ADDENDUM NO. 2

PROJECT: ITB PW 65-20 SOUTHWEST CRESTVIEW BYPASS (PHASE V AND EAST-WEST CONNECTOR)

August 28, 2020

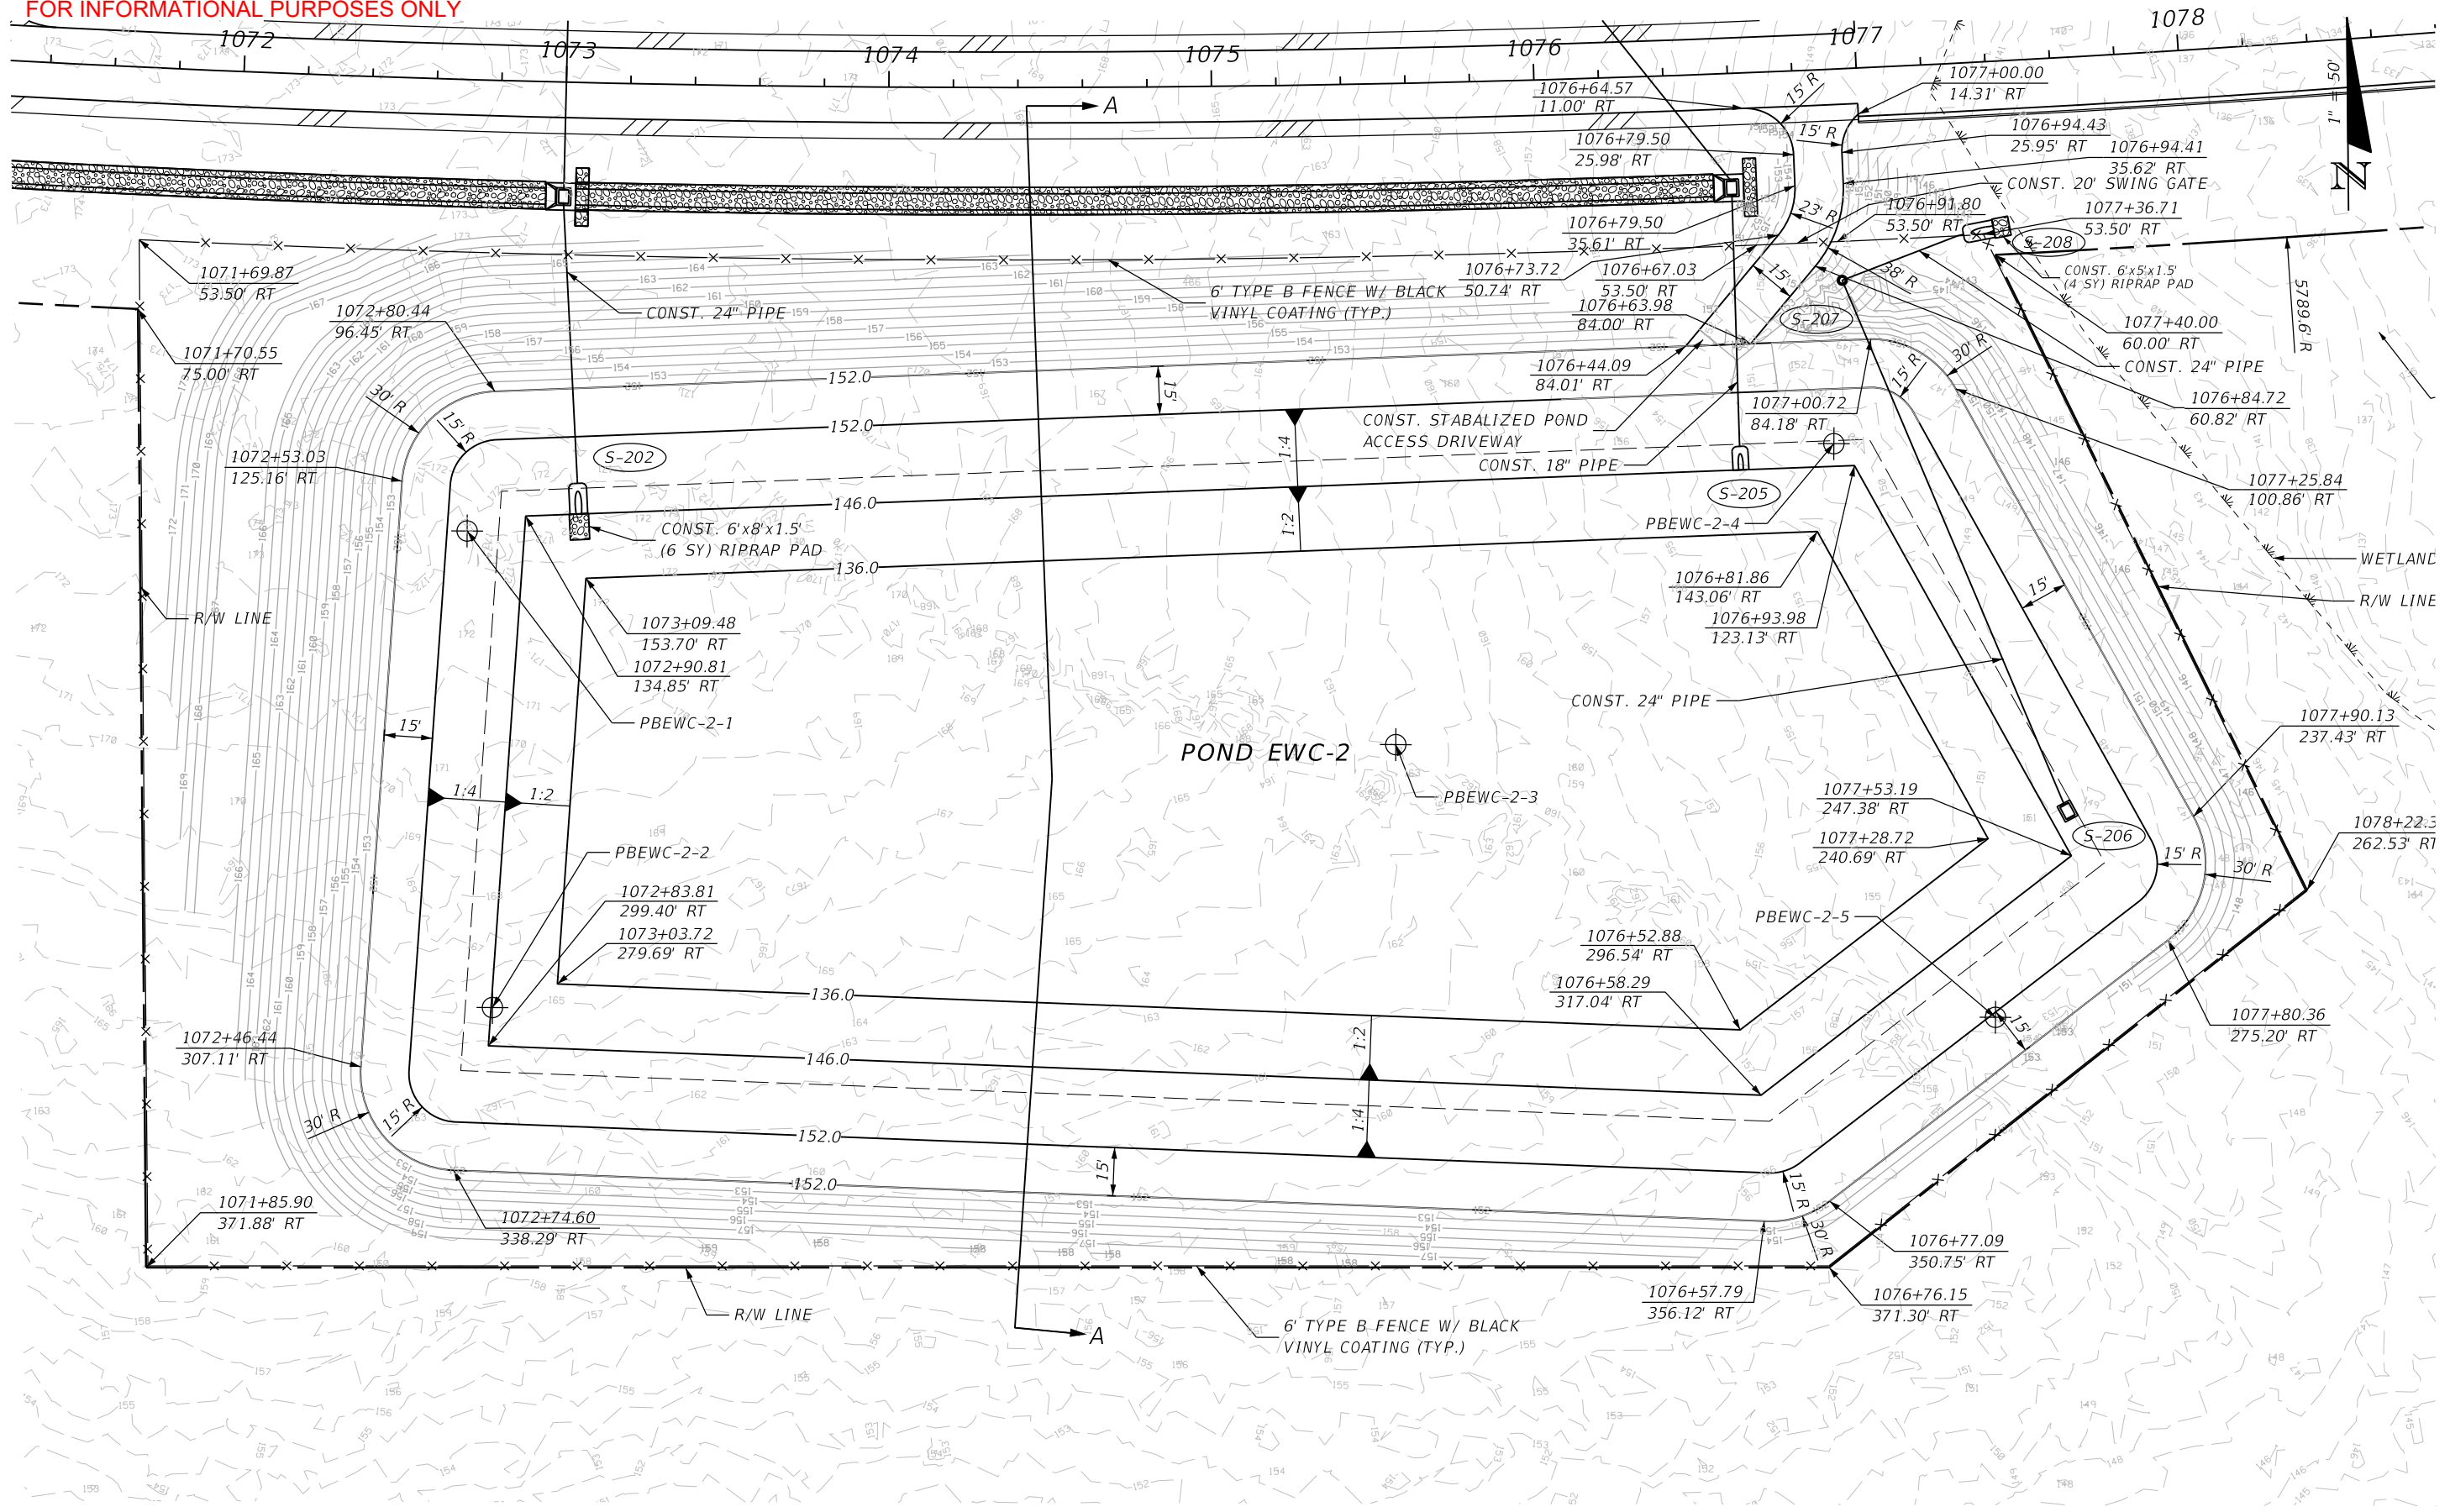
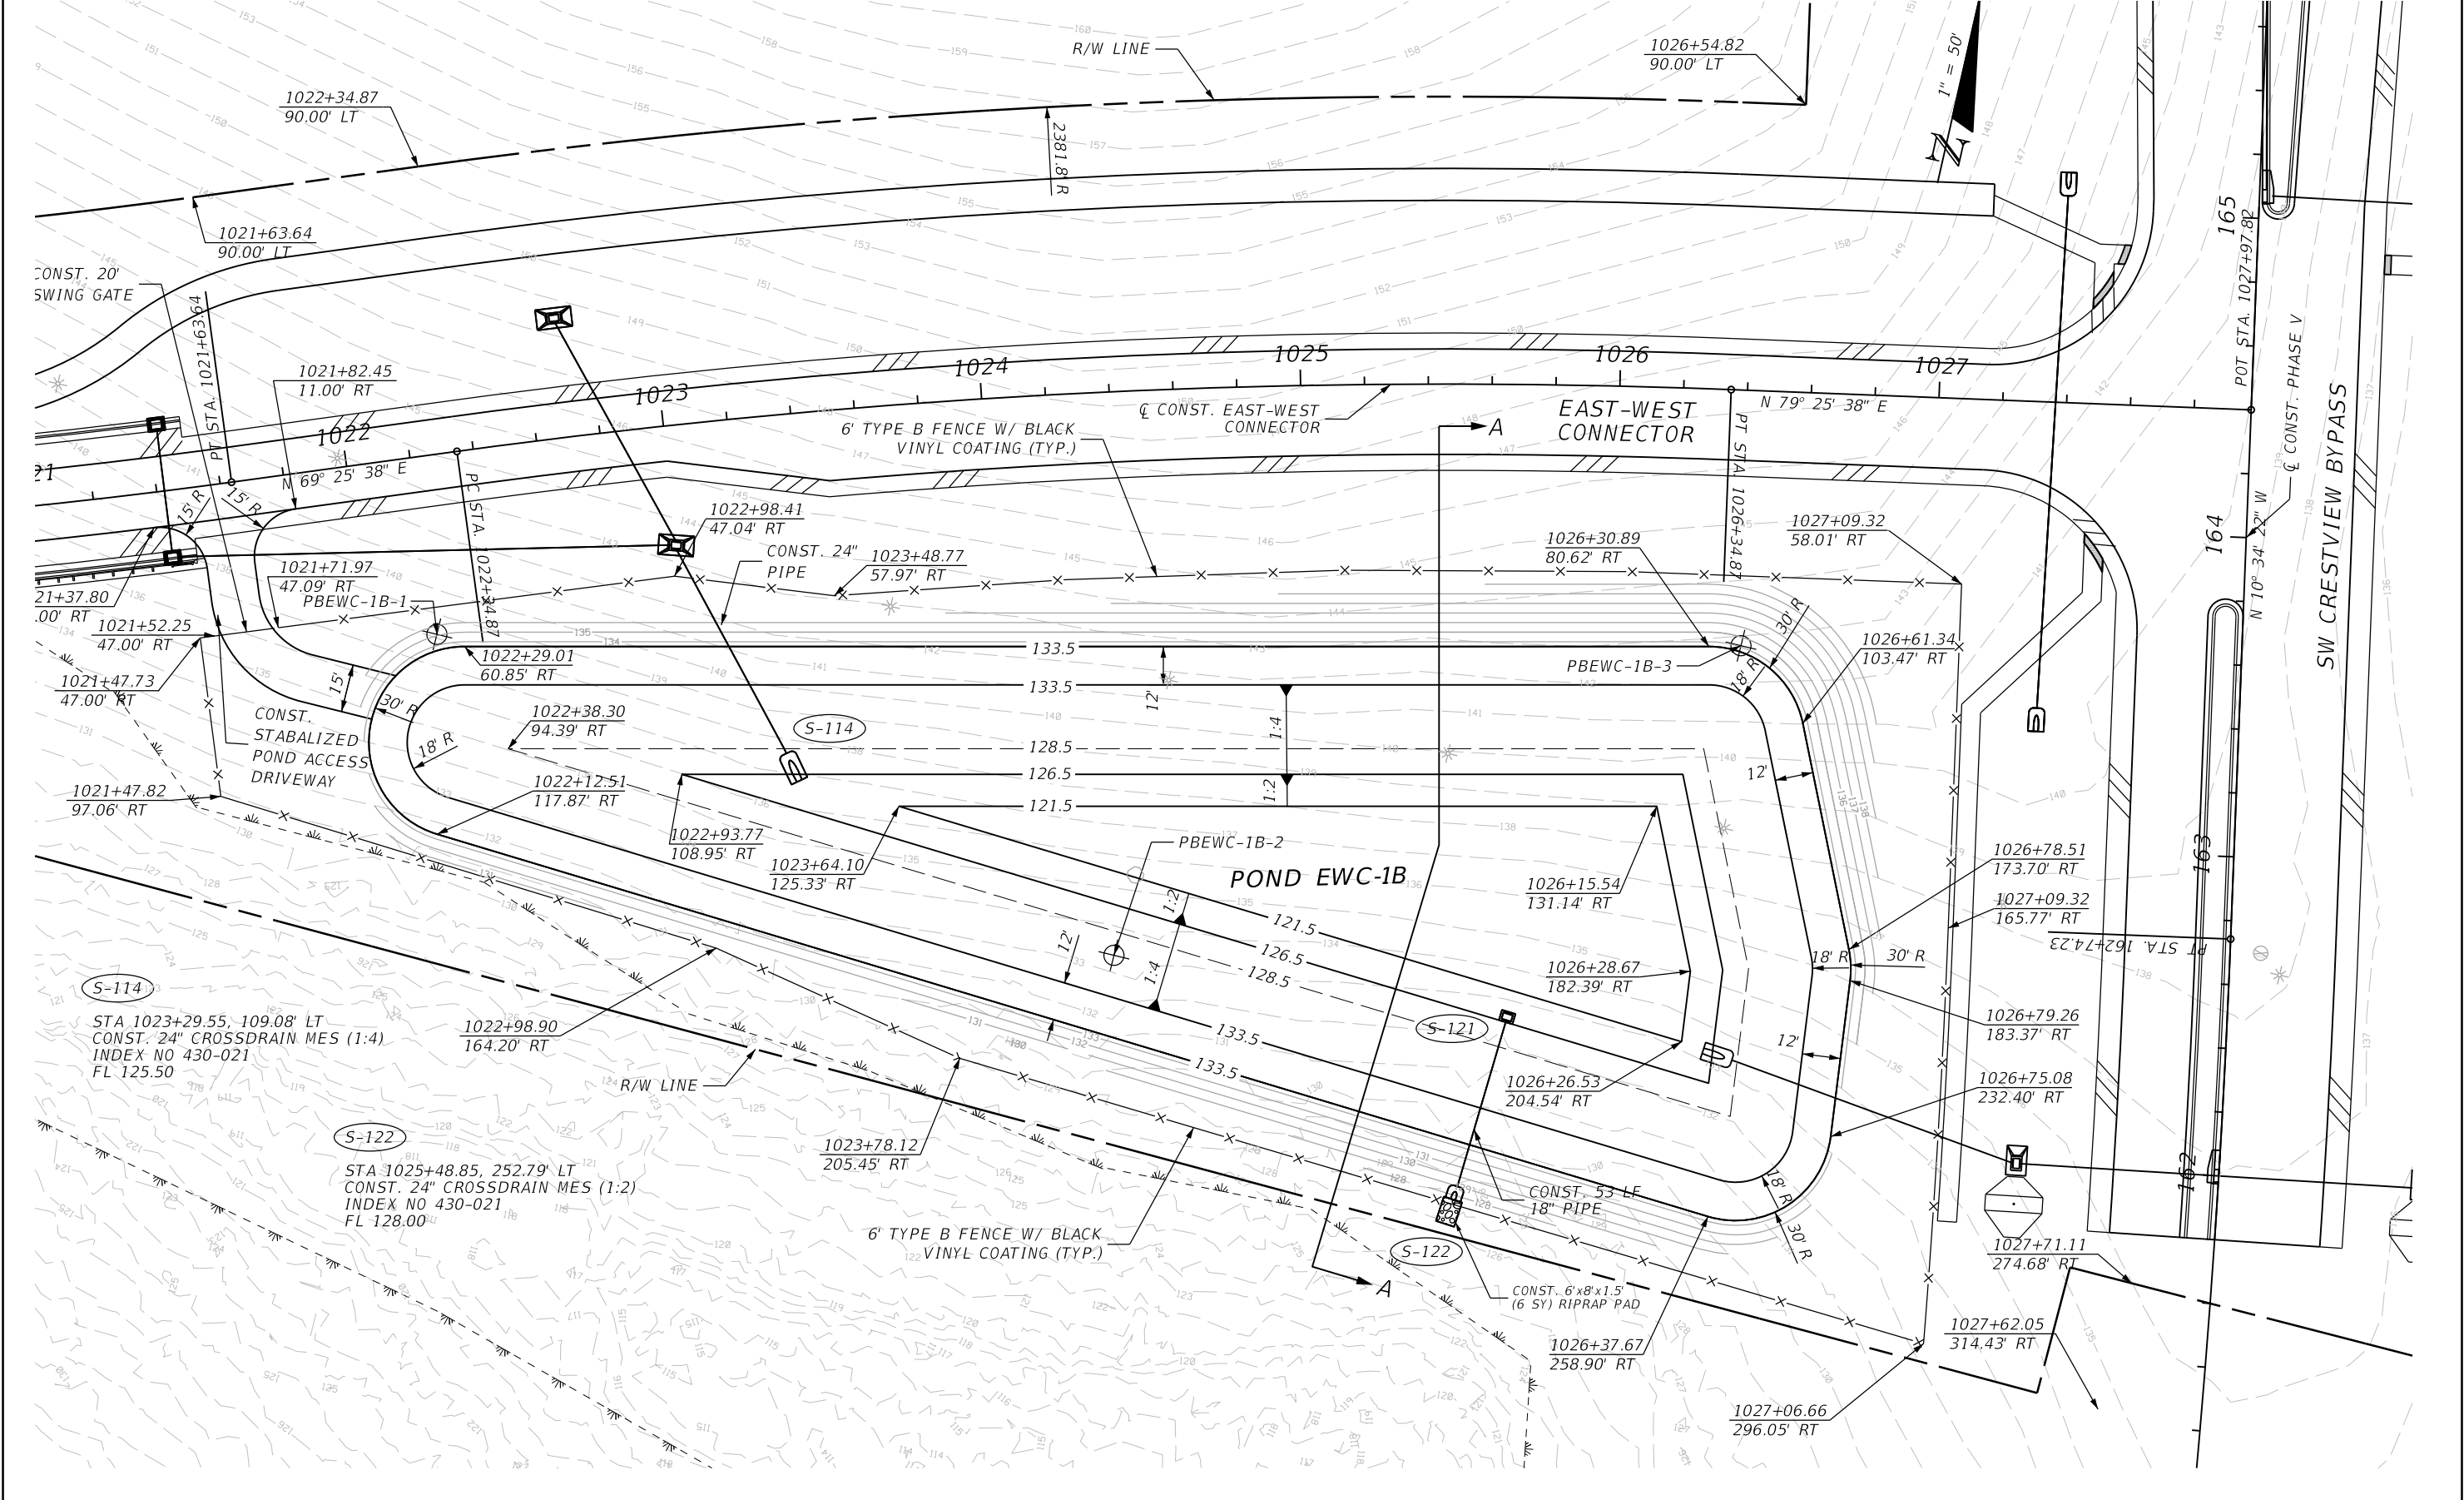
Question 4: *“Can pond plan sheets (102-111 E-W Connector) be provided that contain existing contour lines?”*

Answer 4: Copies of pond plan sheets 102-111, E-W Connector that depict the existing contour lines are attached to this Addendum. The sheets are marked For Information Only.
